KINGSTON FOSSIL PLANT

REPLACE KENNEDY WEIR

RE: Proposed modification to approved construction and operation plans-TVA Kingston
Fossil Plant Landfill IDL 73-0094

ADVANCE AUTHORIZATION FORM

ATTACHMENT 1

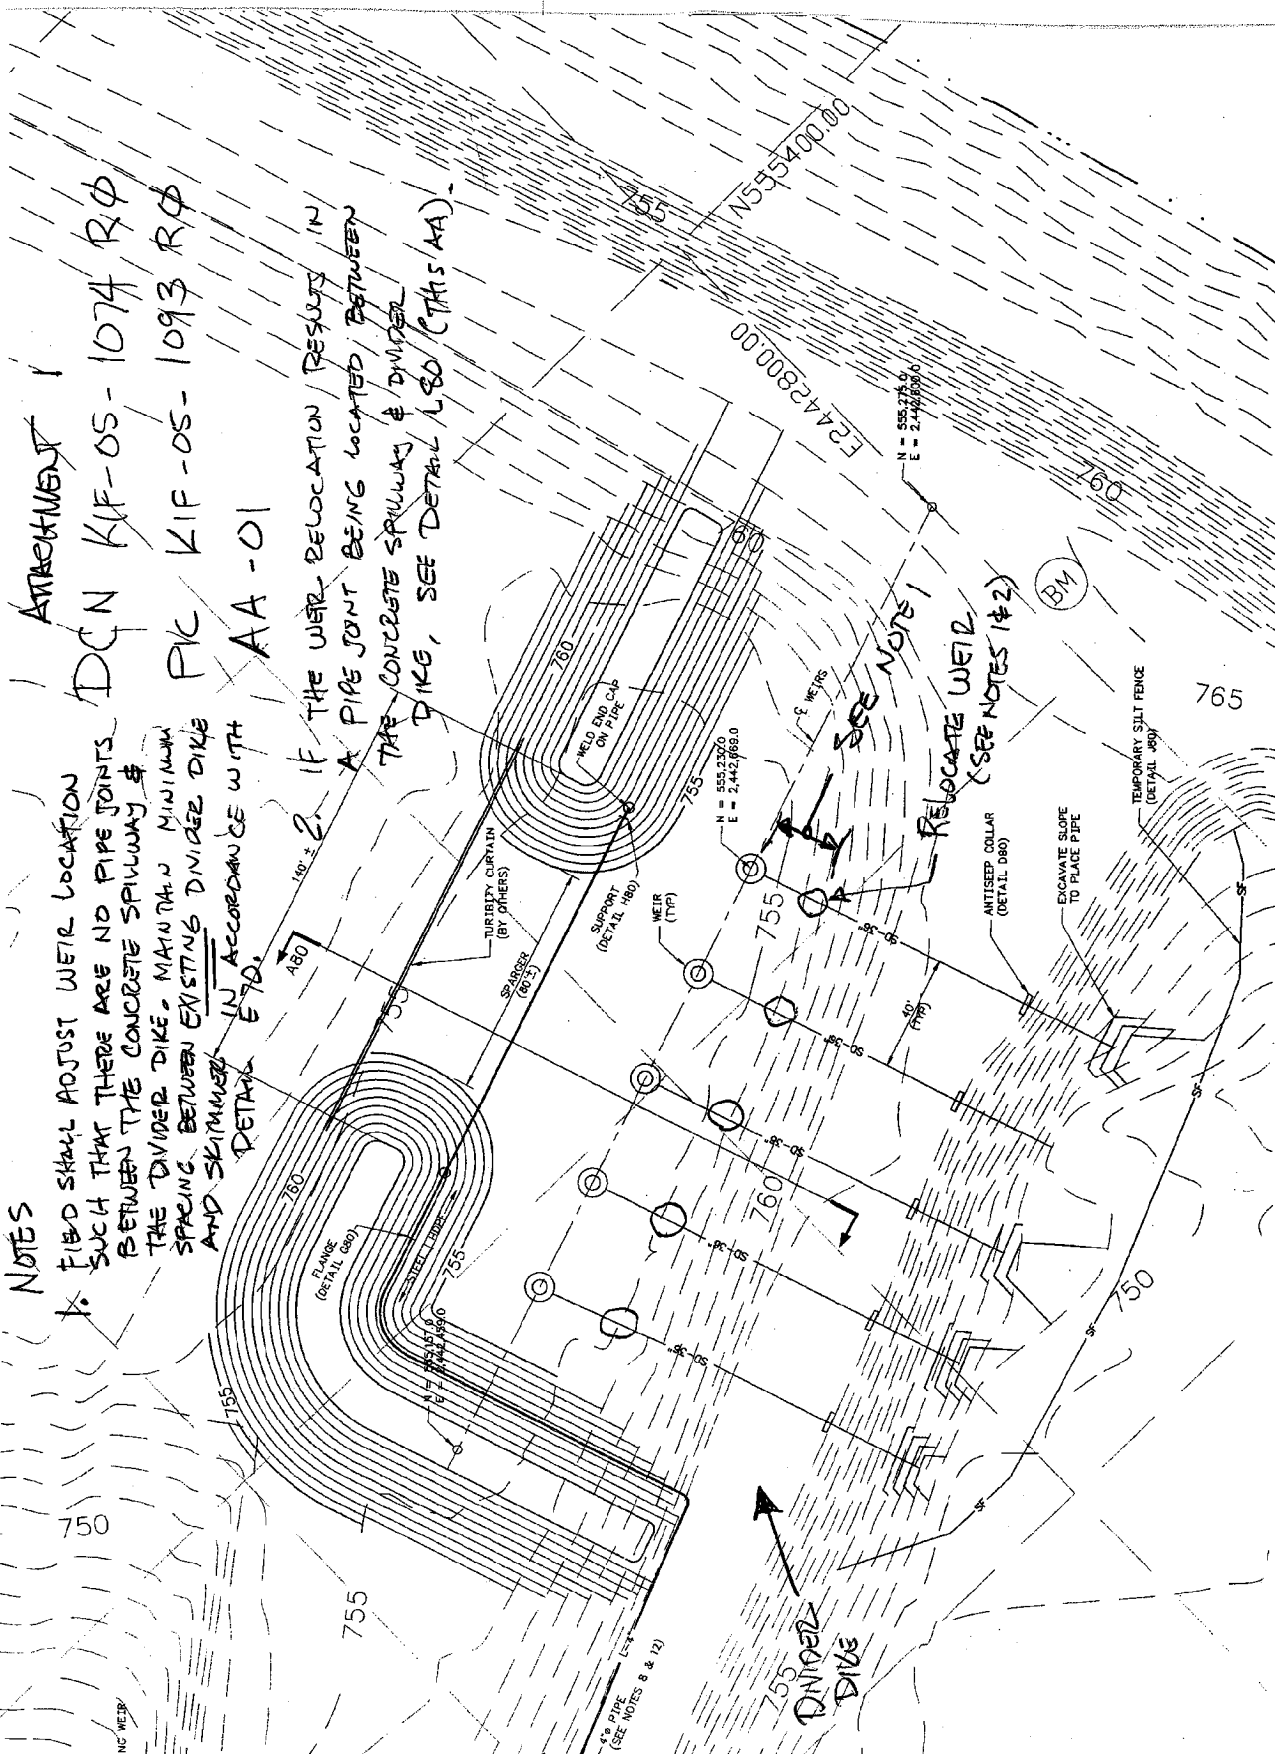
1. Relocate weirs closer to existing divider dike so that there are not pipe joints in the 36 in dia RCP between the divider dike and the concrete spillway. The other alternative is to place additional concrete on the pipe to provide adequate ballast.

* FIELD SHALL ADJUST WEIR LOCATION SUCH THAT THERE ARE NO PIPE JOINTS BETWEEN THE CONCRETE SPILLWAY & THE DIVIDER DIKE. MAINTAIN MINIMUM SPACING BETWEEN EXISTING DIVIDER DIKE AND SKIMMER IN ACCORDANCE WITH DETAIL E70.

DETAIL 1 & D
 (NEW)
 (10W425-80)

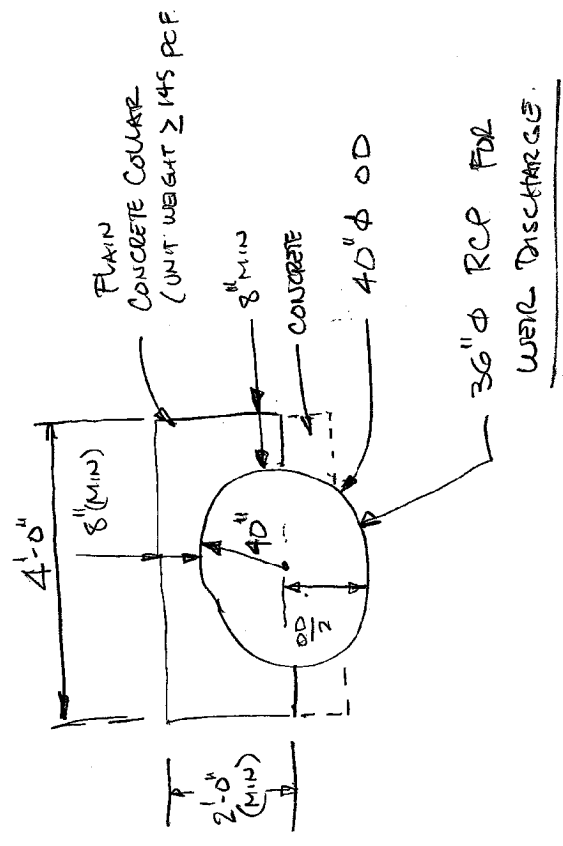
IF THE WEIR RELOCATION RESULTS IN A PIPE JOINT BEING LOCATED BETWEEN THE CONCRETE SPILLWAY & DIVIDER DIKE, SEE DETAIL L80 (THIS AA).

SECTION A80-A80
SCALE: HORIZONTAL: 1"=20'
VERTICAL: 1"=10'

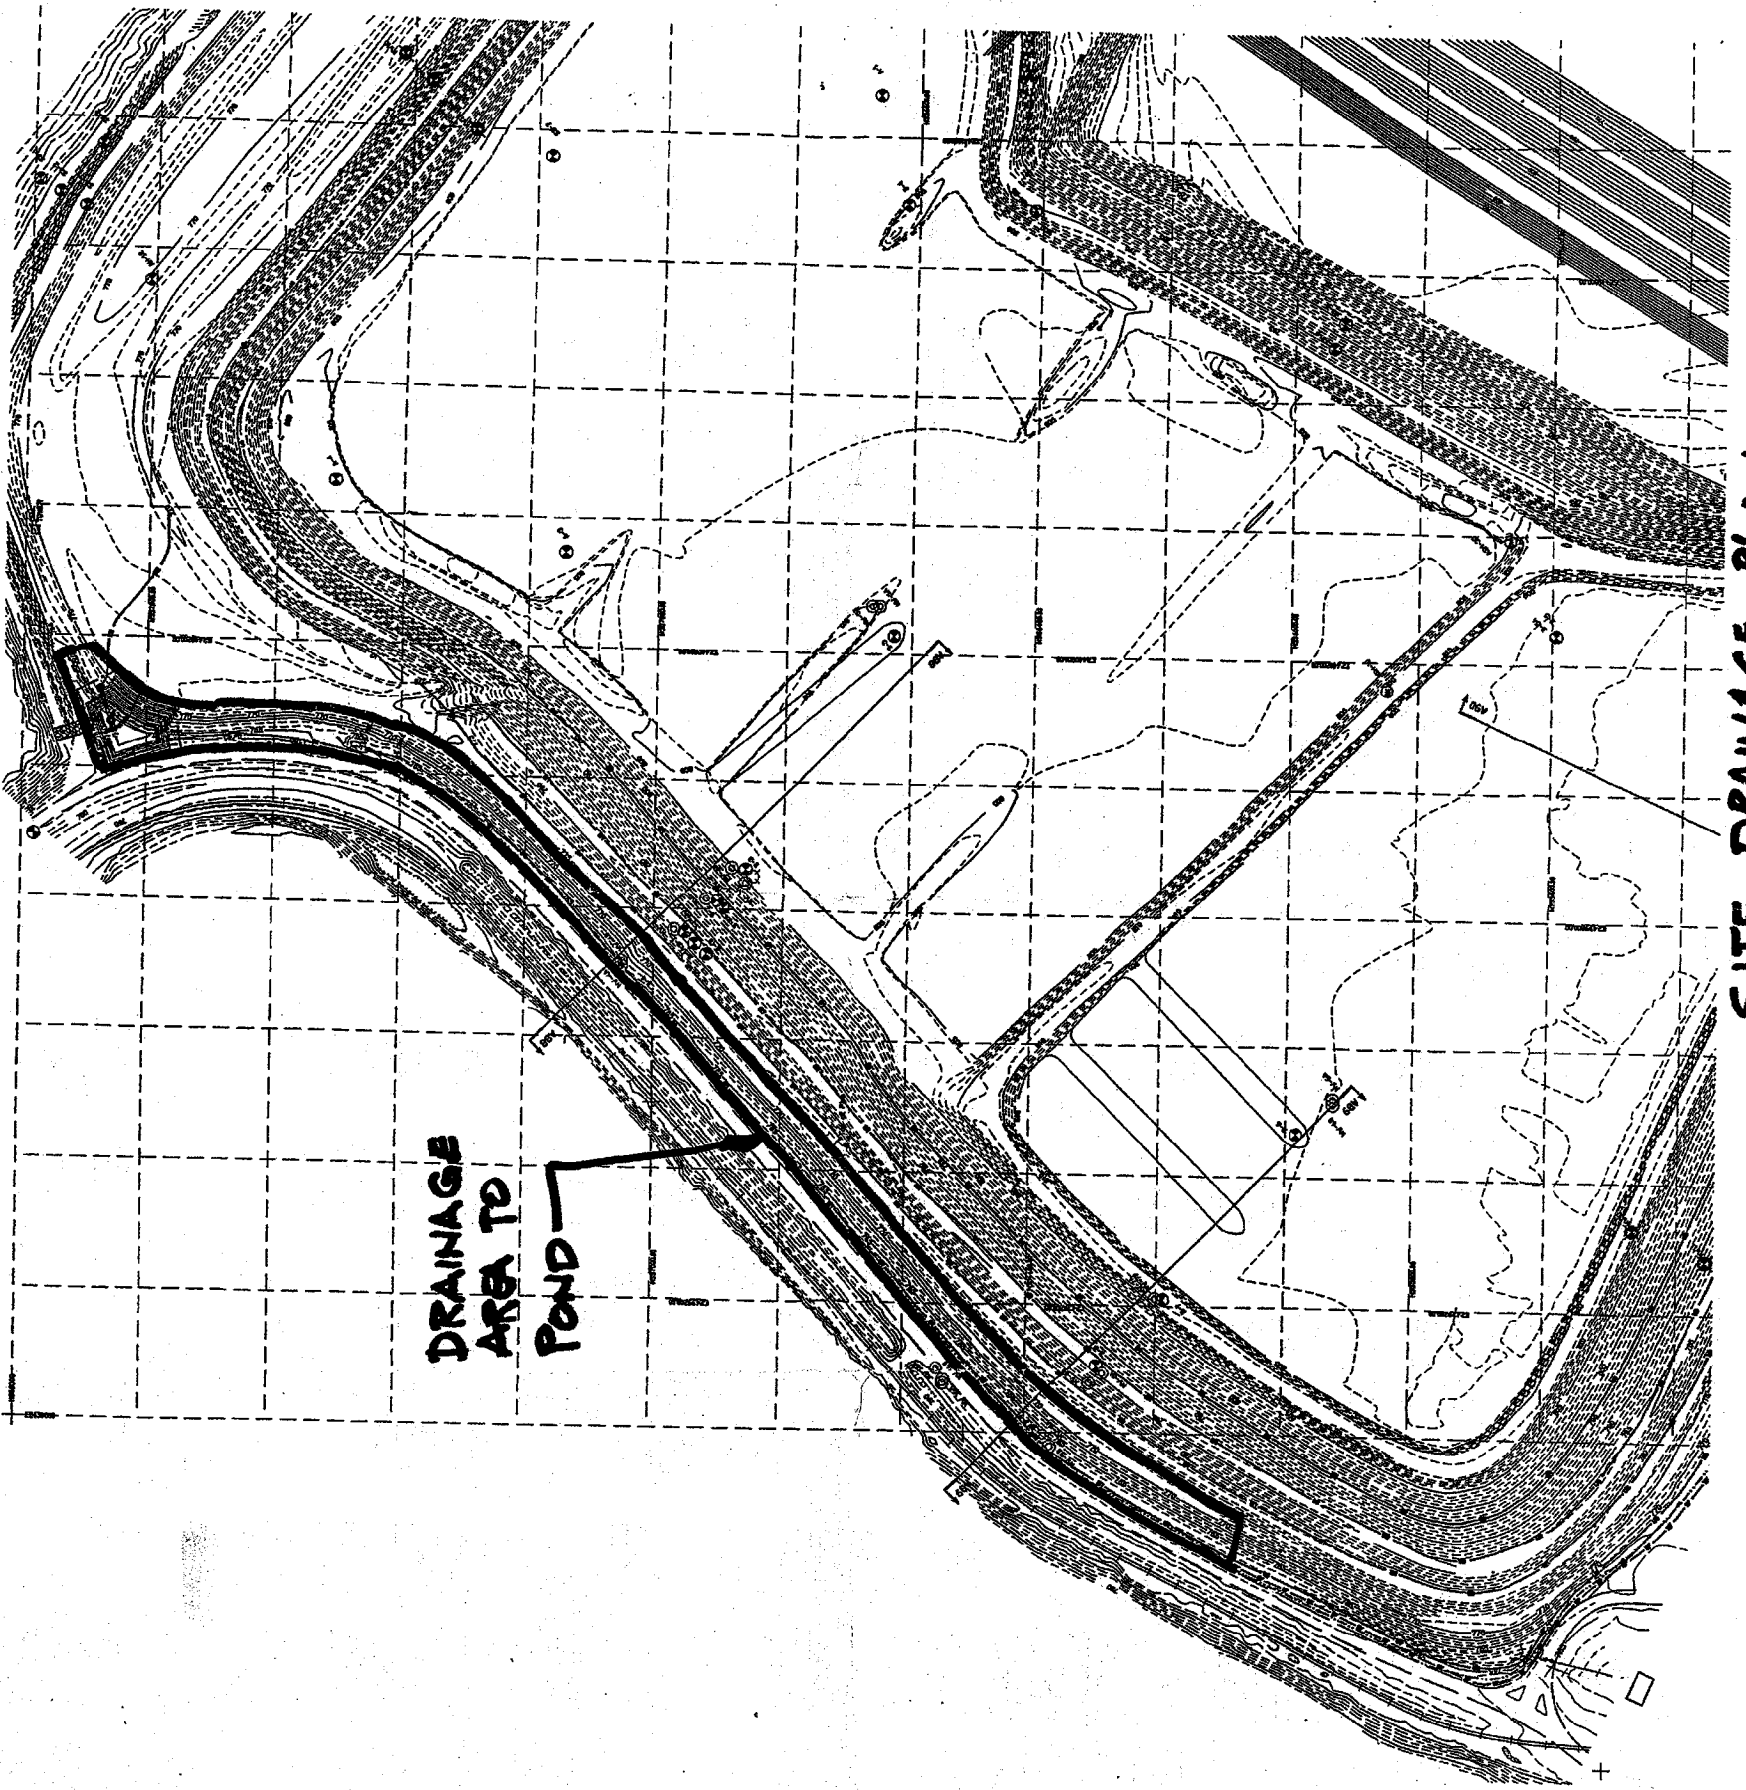
1. Provide riprap surfacing to the outer face of the new dike (constructed for the new weir installation) for slope protection, as shown on the attached sketch.

Provide riprap surfacing to the outer face of the new dike (constructed for the new weir installation) for slope protection, as shown on the attached sketch.

See attached sketches to this AA.
